Building Permit Application

Amendment, Permit # B16 00 2265

5004 Bee Frances way Clarksville MD 21029 to
change the house type from an Empress II to a
Chapel Hill II with ELV's, 2 car garage, 1 car side attached
garage, morning room, 4' ext to family room, sitting area with
covered porch and finished lower level.

**5004 BEE FRANCES WAY, CLARKSVILLE MD
 GREENBERRY LOT 1
 HOWARD COUNTY
 FIFTH ELECTION DISTRICT
 SITE PLAN FOR BAT INSTALLATION**

PLOT PLAN (SITE SPECIFIC)
 GREENBERRY
 LOT 1

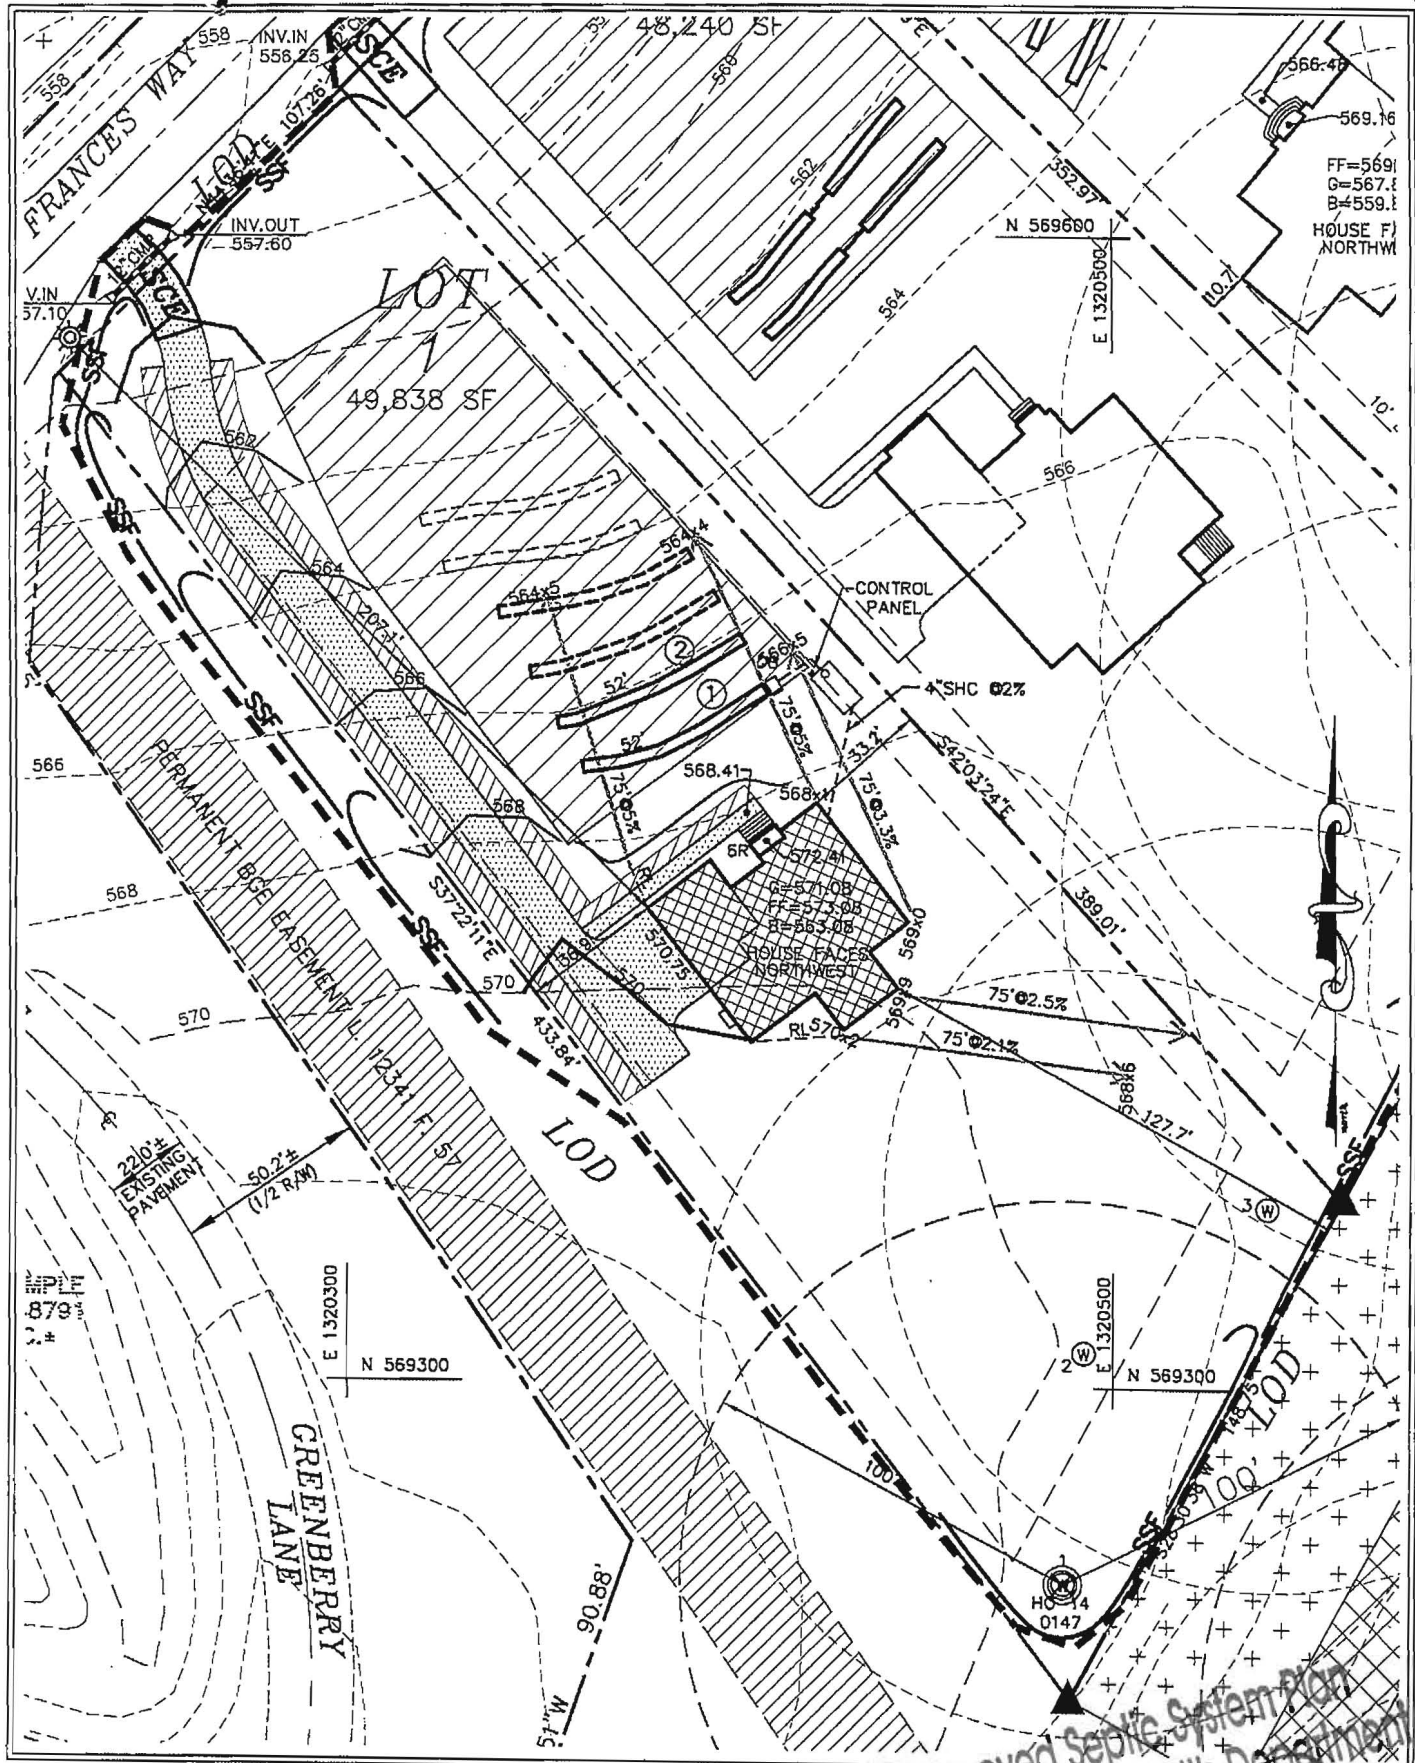
Approved Sep 2015 System Plan
 Howard County Health Department
 6-Bed room SFD revised
 RB [signature]
 5004 Bee Frances way
 8/15/2016

REVISED
 Date: 8/9/16
 Comments: B16-2265
 House Type Change

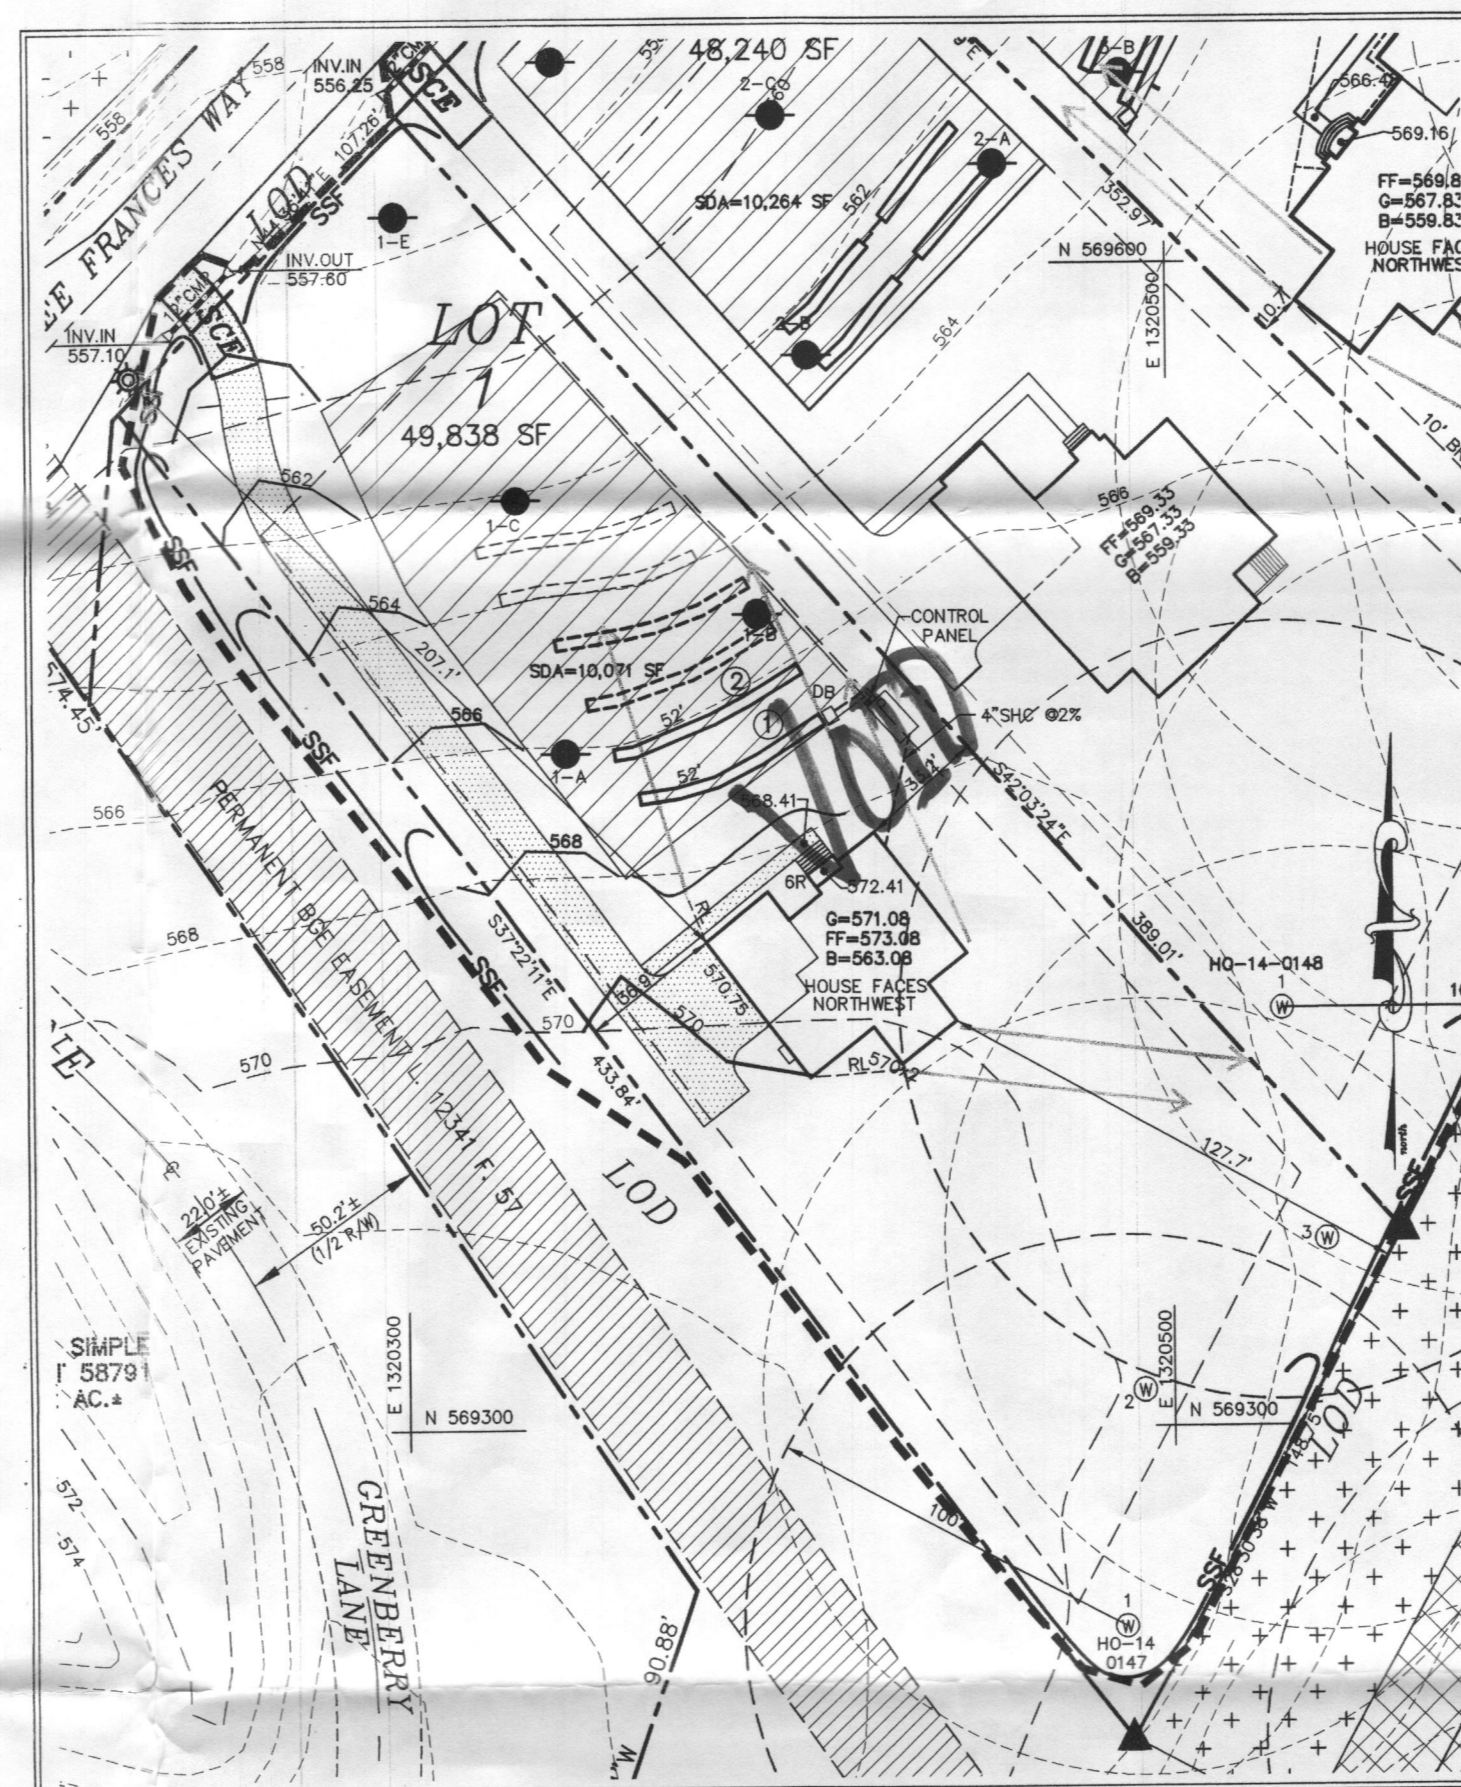
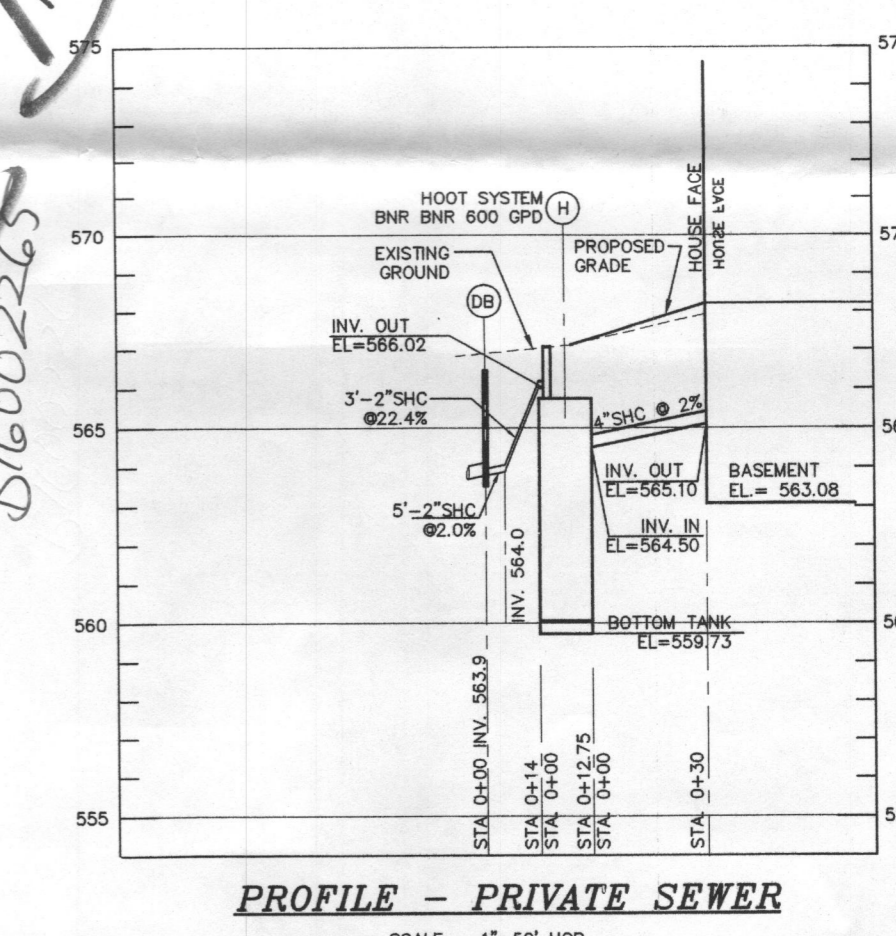
There is a discrepancy between the floor plan submitted to me and the driveway access to the house. The floor plan illustrates a house that would be accessed by a driveway on the right side of the lot, rather than the driveway on the left side as is illustrated in the revisions I am reviewing.

Please be advised that I cannot complete comments on a BAT Plan, and will not approve a BAT Plan, without reviewing the floor plan.

Maya, I will have comment on the BAT Plan, though I see that there is need for clarification of related issues.

1. As the house is reversed, there is need for a REVISION of the Plot Plan to be submitted to DILP.
2. There is a conflict between the floor plans which illustrate 4 bedrooms, and the BAT Plan which has a system proposed for 6 bedrooms. This also may indicate that a REVISION of floor plans should be submitted to DILP.

Hi Robert. All of our floor plans only show a per plan home (meaning driveway right) if the house is flipped to a reverse layout the site plan only shows this as the plans are interpreted as a mirror image changing to the opposite side. Please let me know if you need additional information or this clears this issue up for you
